Troubleshooting Guide: “No Console” Error	
Prepared by: Regina Templeton	Date Prepared: 3/2/2015	Models Affected: AFG 7.3AIC, Horizon Elite IC7

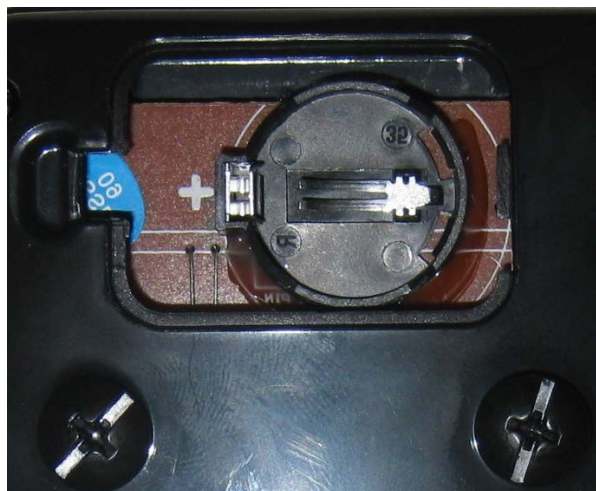
Improper battery installation in the console may cause a “No Console” error on the AFG 7.3AIC and Horizon Elite IC7 models. If the battery is placed on top of the positive (+) pins in the battery compartment, the console does not operate.

The console battery compartment is redesigned. The production serial number breaks are shown below:

The negative (-) side of the battery must press on the negative (-) pins, and the positive (+) pins must press on the positive (+) side of the battery. If the “No Console” error shows, follow these steps to align the pins:

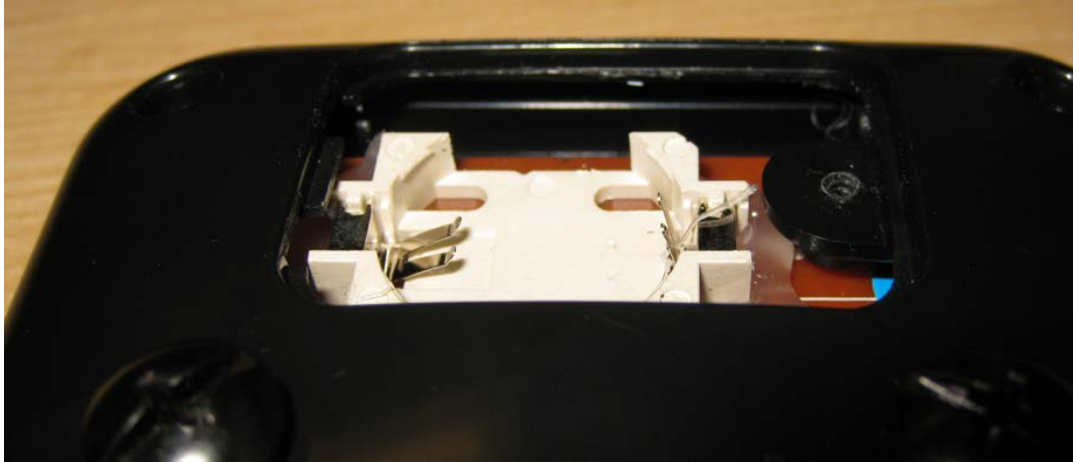
1. Use the screwdriver to remove the cover from the battery compartment on the back of the console.

2. Bend the positive (+) pins up on the right side (beside the hole for the compartment cover screw), as shown below.

3. Insert the battery at an angle with the positive (+) side facing up. Make sure to keep the positive (+) pins upright as shown below.
